**CITY OF NEWPORT BEACH**

**Re: Letter of Appeal for Revision of the Preliminary FIRM and BFE for the City of Newport Beach  
Community No.: 060227  
Case No.: 12-09-1324S  
Docket No. FEMA-B-1673**

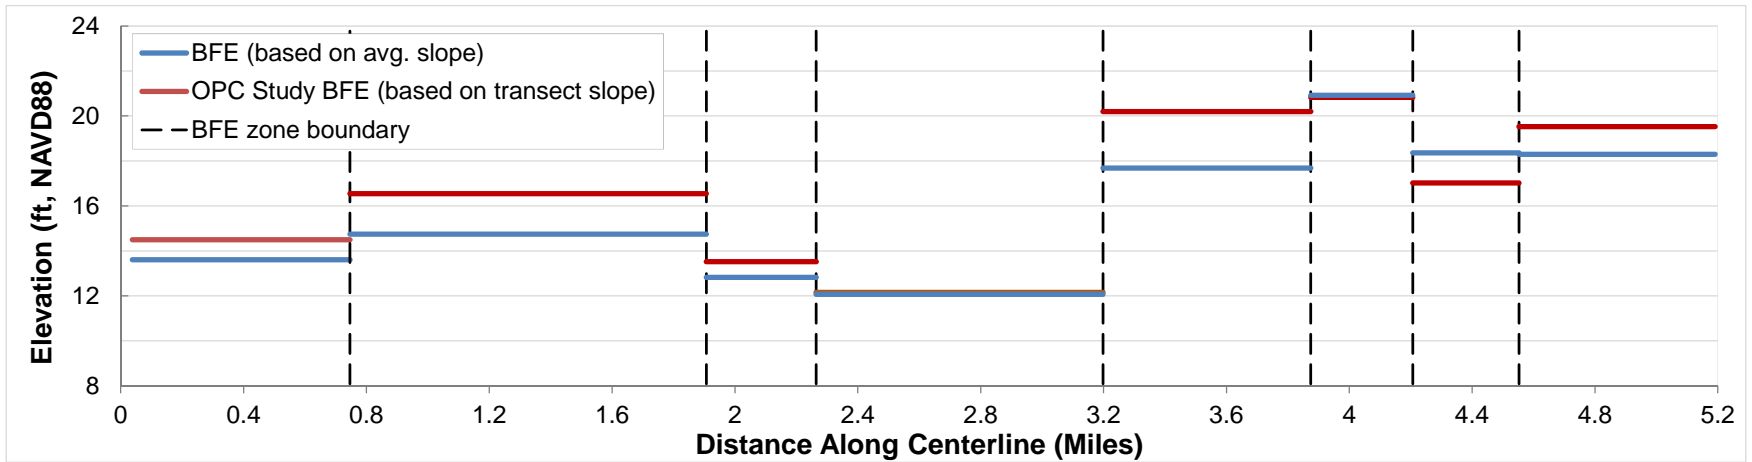
BFEs along the open coast were defined by the 1% annual exceedance probability wave runup elevations, which were referred to as total water levels (TWLs) in the OPC Study. The 1% TWLs were determined by conducting wave runup analysis at representative transects of the foreshore beach slope and shoreline orientation for distinct shoreline reaches. The 1% TWLs calculated at each representative transect are rounded to the nearest whole foot to define the BFE for the corresponding shoreline reach. Figure 10 shows the transect locations along the shoreline that were used for wave runup analysis in the Newport Beach area. The *blue* lines represent the transects used for Newport Beach in the OPC study. The figure also shows the BFE Zones and the VE extents for each of the shoreline reaches, which were calculated based on the slopes of the corresponding transects. The OPC Study used only a few beach transects to represent the entire Newport Beach coast; this means that a single beach slope taken at each transect is being used to define an extended shoreline reach. We understand that for mapping purposes, it is reasonable to represent the shoreline with limited number of BFE zones. However, since there is significant variability in foreshore beach slope within shoreline reaches, it is technically accurate to use the average beach slope—instead of using only a single beach slope where the transect happens to be located—along each reach to calculate the corresponding BFE for that shoreline reach.

Also shown in Figure 10 are cross-shore transects taken at 200 ft. (61 m) intervals along the Newport Beach Coast. We used these transects to determine the average foreshore slope within each shoreline reach. Figure 11 compares the foreshore beach slopes of OPC transects 16 to 24 with slopes determined using the 200 ft. (61 m) transect spacing. The average beach slopes within each shoreline reach are also shown in Figure 11. The boundaries of shoreline reaches, which define changes in BFEs, are shown in the same figure as *black* dashed lines. The OPC foreshore beach slopes of transects 16, 17, 18, 20, 23 and 24 are generally larger than the average foreshore slopes in their respective reaches. Since the BFEs are assigned to an entire shoreline reach, and there is significant variability in transect slopes within reaches, the open coast BFEs in the Newport Beach area should be determined using the average transect slope within each shoreline reach.

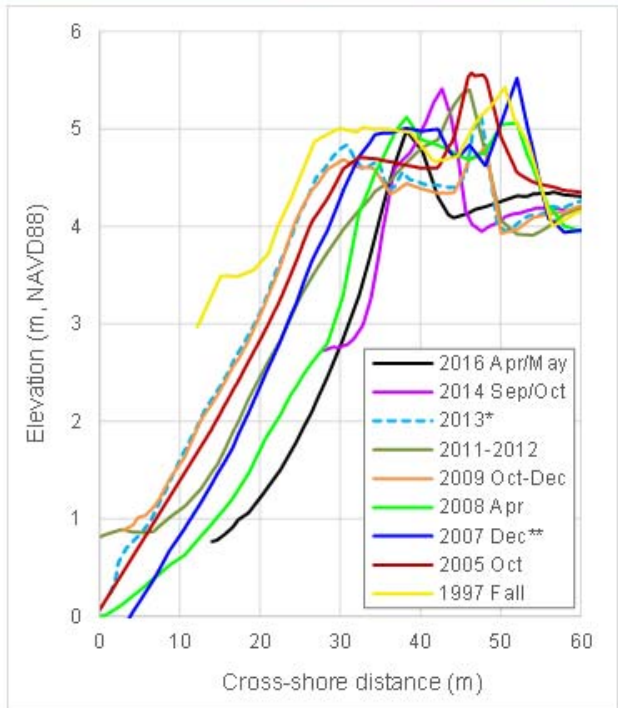
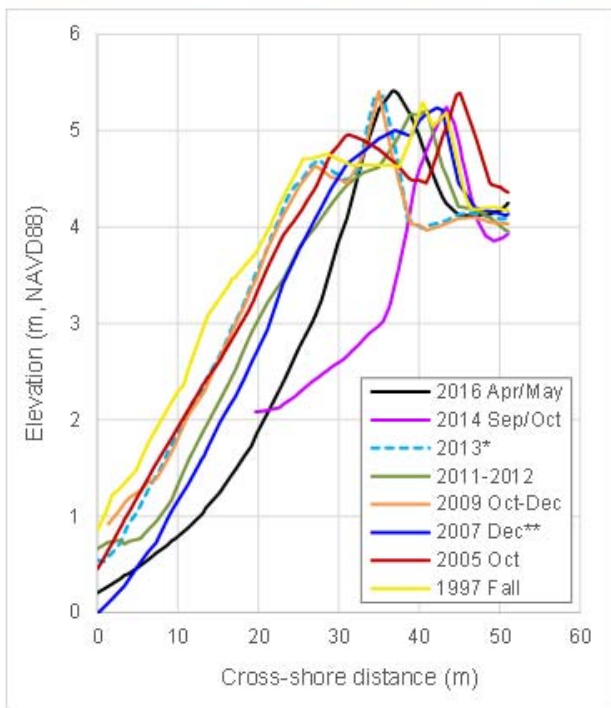
Due to the nature of these berms, it is unlikely for such features to appear in elevation data sets. However, they are constructed in advance of large ocean swells, the inclusion of the berms in the beach profile represents a much more likely winter condition. The aerial photo (Figure 13a) illustrates the typical location of beach berms along the beach profile. The geometry and characteristics of these beach berms in the Newport Beach area have been reported by Gallien et al. (2015) and documented in Appendix M of City of Newport Beach (2017). As illustrated in Figure 14, these beach berms also showed up in LIDAR (Light Detection and Ranging) data surveyed from 1997 to 2016.

Figure 15. Proposed Revised VE Zone Extent for Zone 16

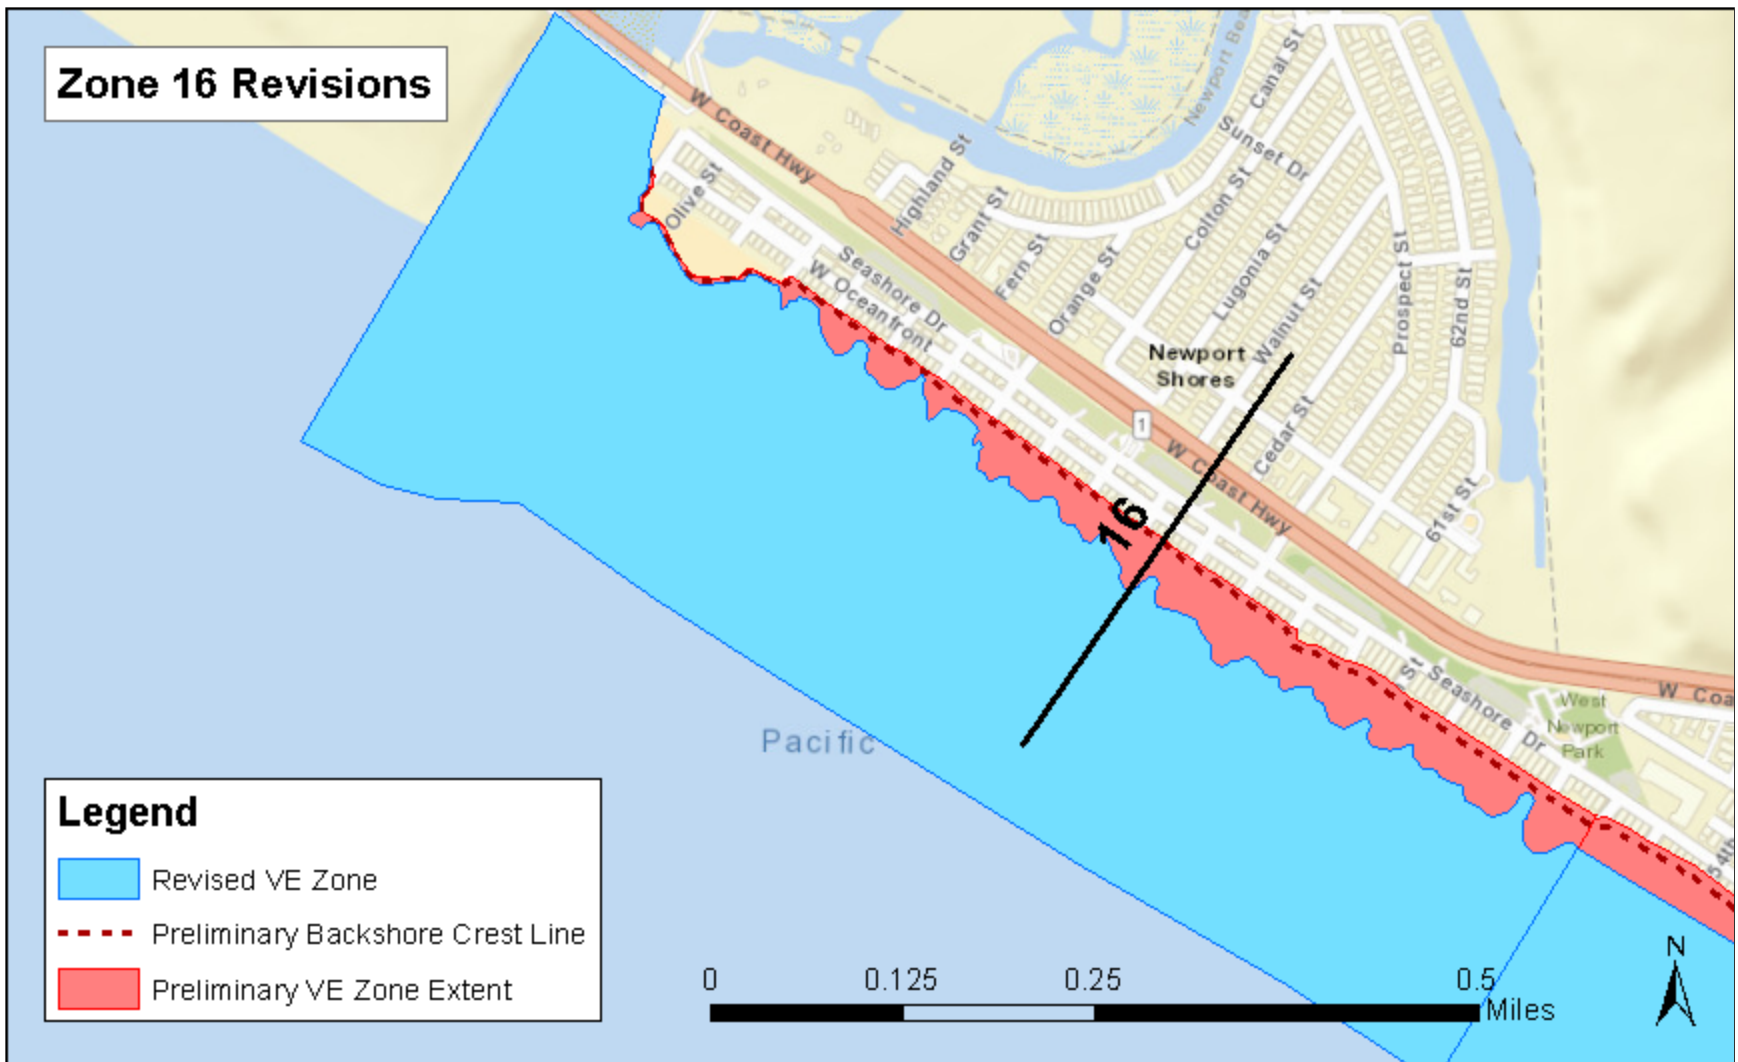
In Zone 16, the preliminary 1% TWL overtops the foreshore beach crest and backshore beach profile. The VE Zone extent was therefore based on backshore overtopping analysis in the OPC Study. However, the revised 1% TWL in Zone 16 is not high enough to overtop the backshore dune. Since the revised 1% TWL does not overtop the dune, the revised VE Zone extent is defined as the intersection of the beach dune and 1% TWL. This is consistent with the OPC Study methodology, where in cases when a backshore feature is high enough not to be overtopped, “the TWL is projected to the base of that feature.” Thus, in the revised Zone 16, backshore overtopping analysis was not conducted. Figure 15 shows the revised versus preliminary VE Zone extents. The change in VE Zone extent is based solely on the revised 1% TWL, which reflects the average foreshore beach slope of the shoreline at transect 16.

1. Revise the FIRM for the AE zone to the proposed revised flood map shown in Figure 9b that was developed based on 2D hydrodynamic modeling, a scientifically accurate method. The FEMA method and assumptions (Bathtub model) are scientifically incorrect.
2. For the VE Zone, revise the BFEs to those shown Table 3. The proposed revised BFEs were developed based on an accurate use of the available beach slope data. In addition, revise the preliminary FIRM for Zone 16, 17, 18, 20, 22, and 23/24 to the proposed revised VE zone extents shown in Figures 15 to 20.

Figure 16. Proposed Revised VE Zone Extent for Zone 17

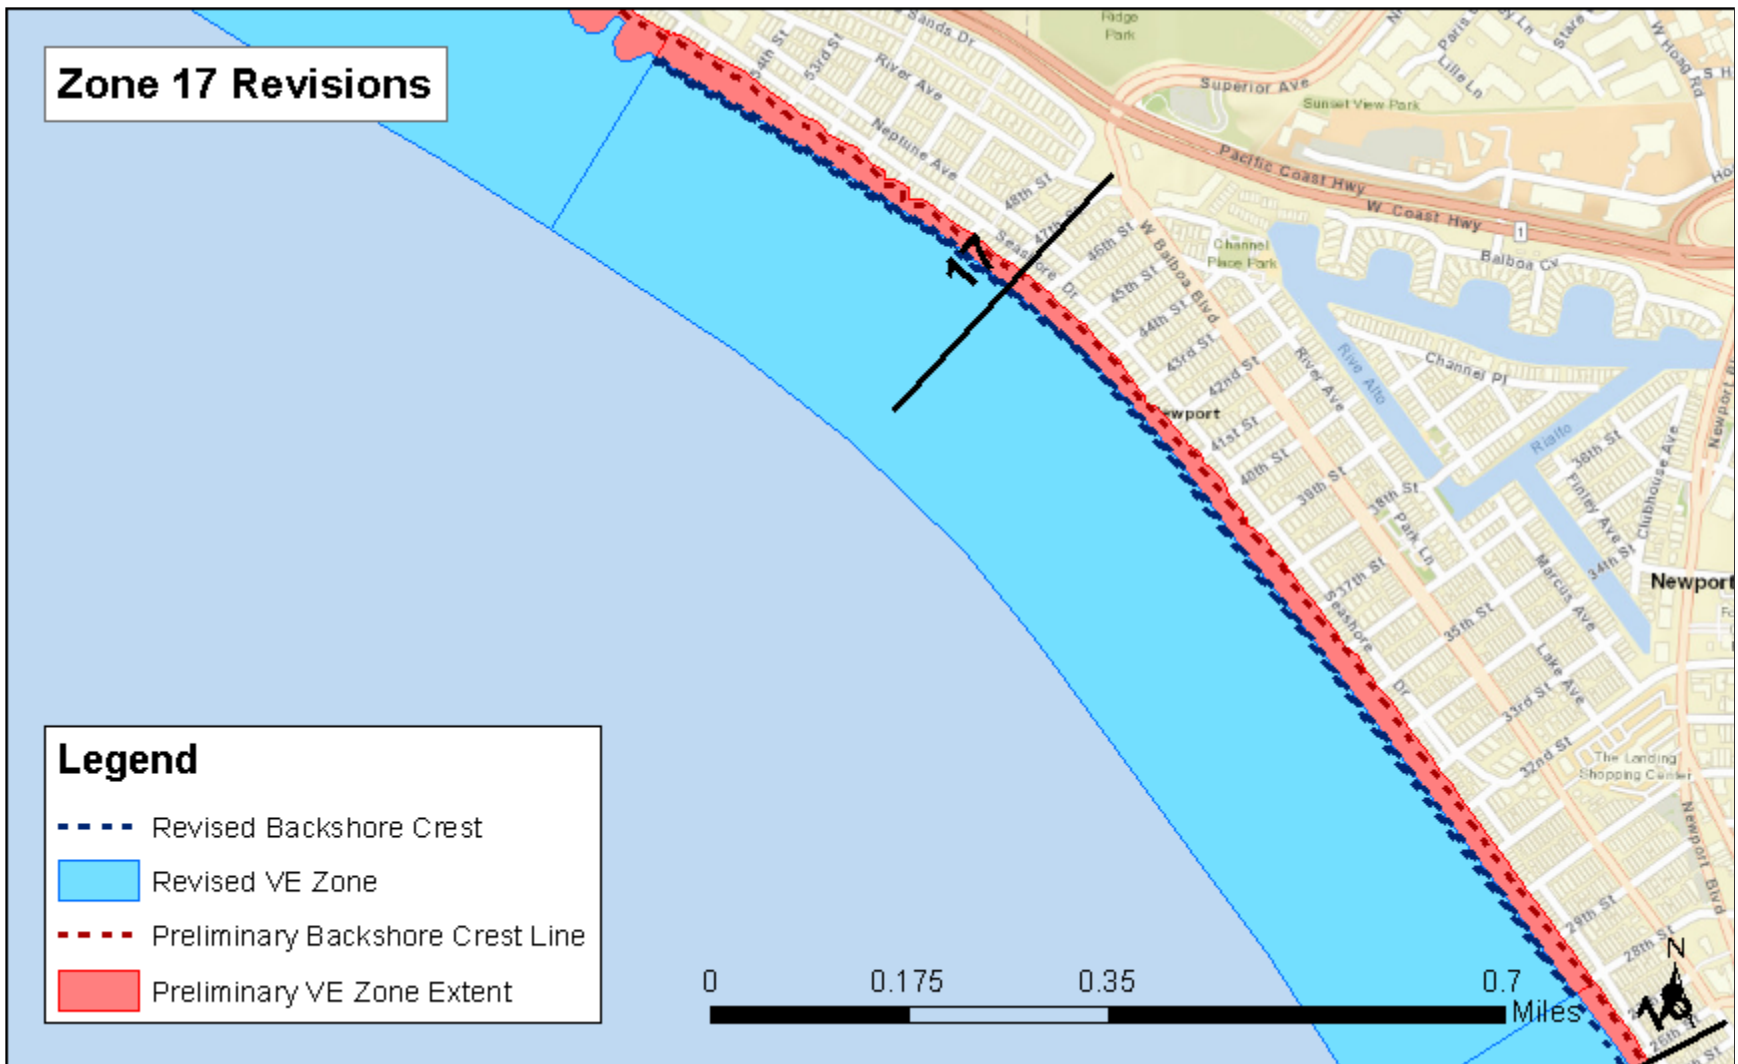
In Zone 17, both the revised and preliminary 1% TWLs overtop the foreshore beach crest and any backshore features. However, in the OPC Study, temporary beach berms were not considered in the transect profile, so the semi-formal seawall adjacent to private properties was selected as a backshore feature. In the revised analysis, the approximate location of temporary beach berms was used to define the location of the backshore feature. The location of beach berms was approximated based on information from Figure 13a and consultations with City staff. The absolute elevation of the berm crest was not required, because we assumed that the berm fails during the 1% event, and overtopping analysis is conducted using the bare earth elevation. Thus, in Zone 17, the revised VE Zone extent is based on selecting a different backshore feature for overtopping analysis. Figure 16 shows the revised versus preliminary VE Zone extents.

Figure 17. Proposed Revised VE Zone Extent for Zone 18

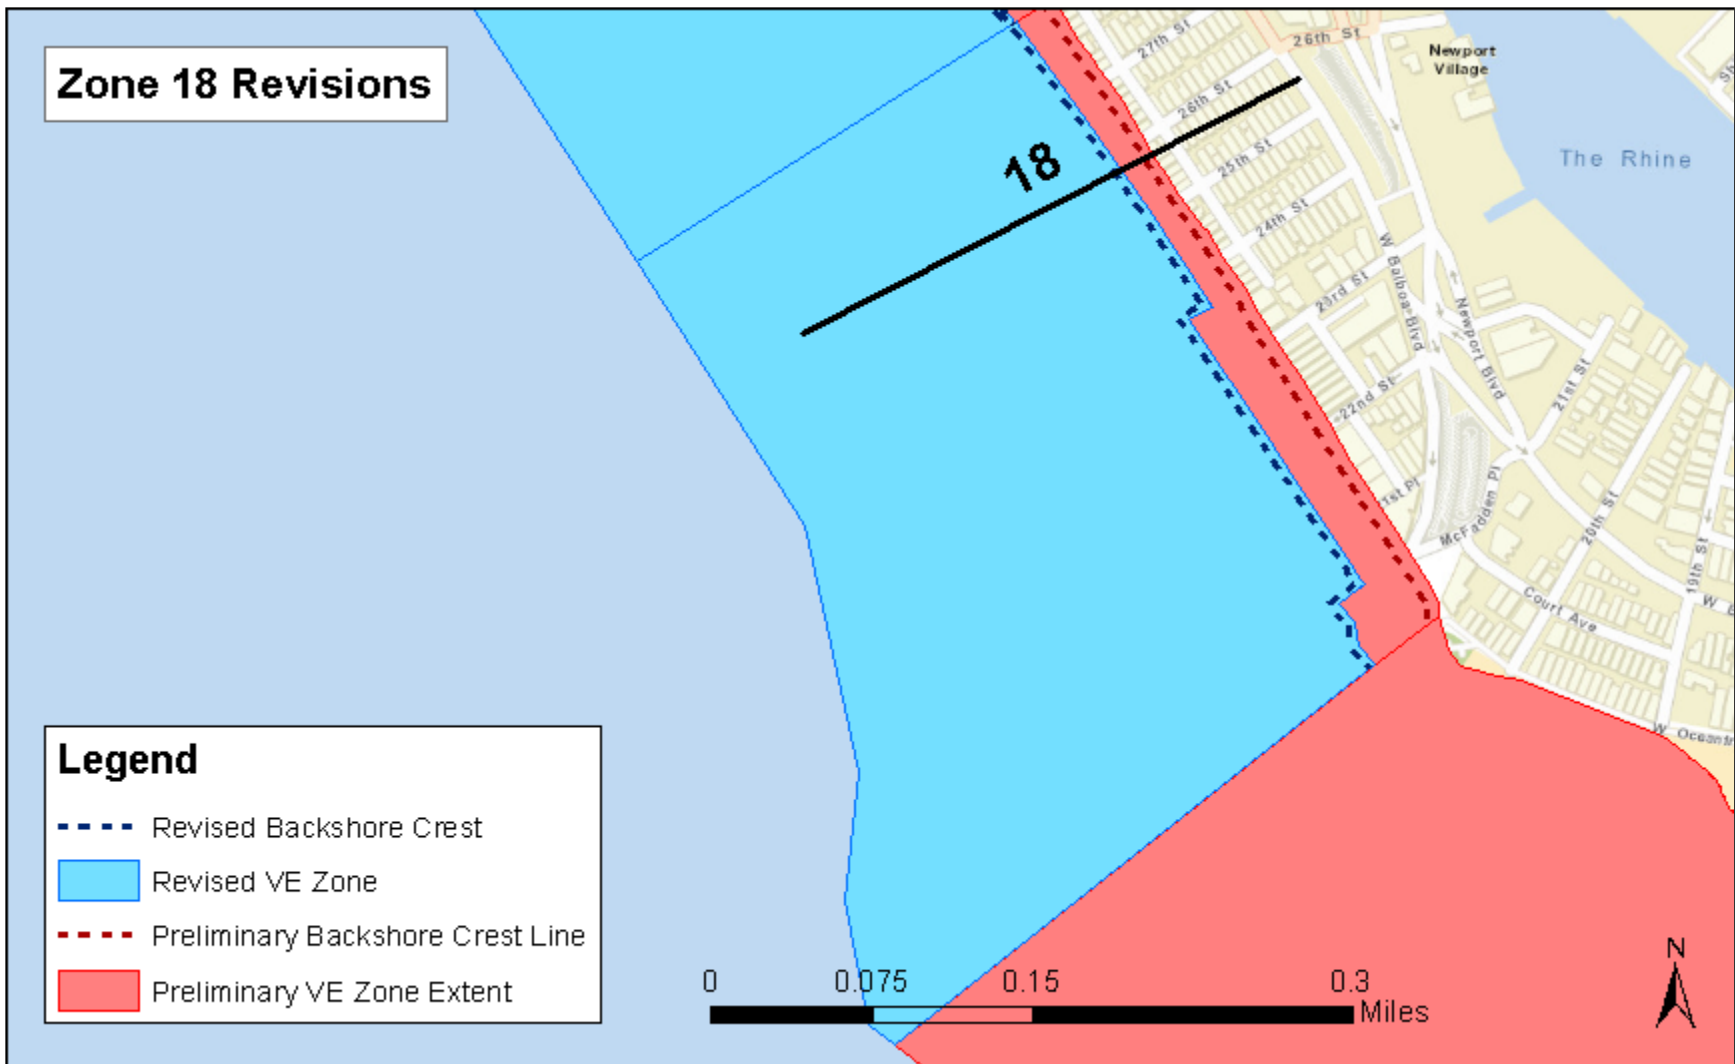
In Zone 18 of the OPC Study, both the preliminary and revised 1% TWLs overtop the foreshore and backshore features. In our analysis, however, we used two backshore features for Zone 18—the temporary beach berm from the BFE zone boundary to 24<sup>th</sup> street, and the seawall protecting the West Ocean Front parking lot from 24<sup>th</sup> street to the Newport Beach pier. The location of the temporary beach berms was again estimated based on information from Figure 13a and consultations with City staff. Though the seawall protecting the West Ocean Front parking lot is an observable crest in the OPC Study topographic data, the private seawall was selected as the backshore feature for all of Zone 18 in the OPC Study. The revised VE Zone extent shown in Figure 17 is different from the preliminary VE Zone extent due to the difference in backshore feature locations.

Figure 18. Proposed Revised VE Zone Extent for Zone 20

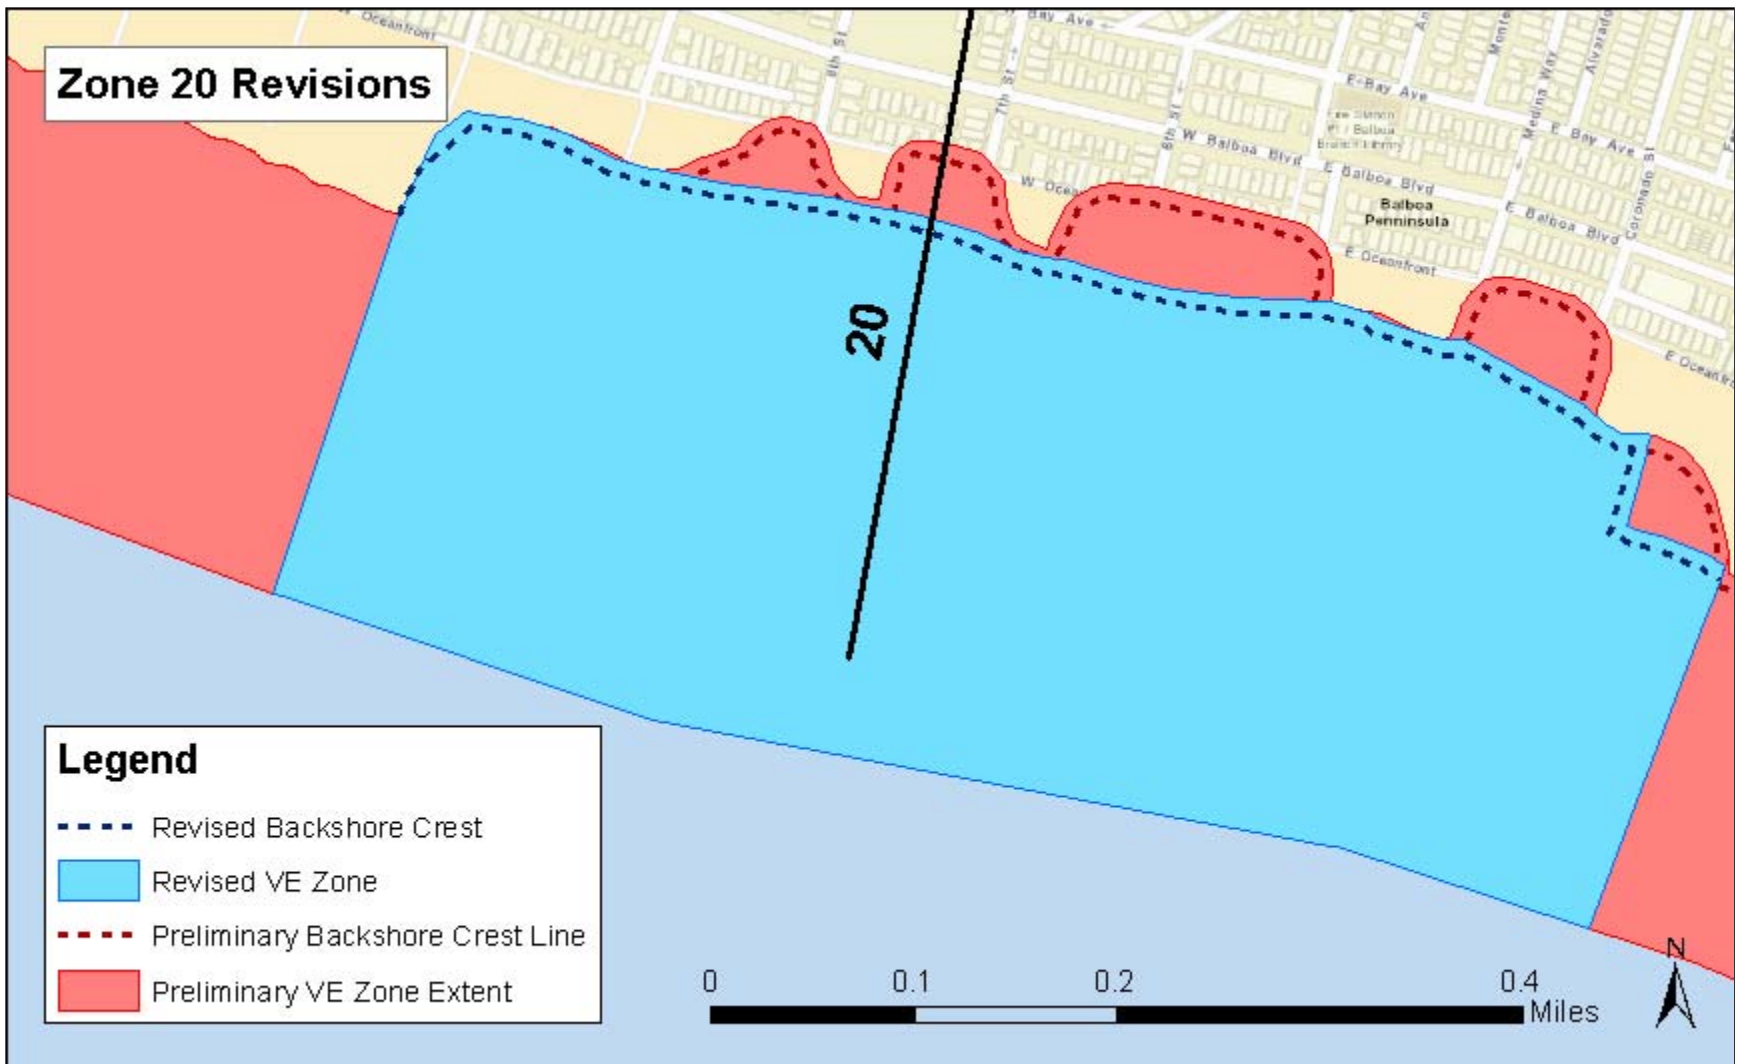
In Zone 20, both the revised and preliminary 1% TWL overtop the foreshore and any backshore features in the beach profile at transect 20. In the OPC Study, the backshore features appear to be the private seawall between sand dunes, and the base of the sand dunes elsewhere within the shoreline reach. In our analysis, we used information from Figure 13a and consultations with City staff to estimate the location of temporary beach berms in Zone 20. The beach berms were again selected as the backshore feature in Zone 20. Figure 18 shows the revised versus preliminary VE Zone extent for Zone 20.
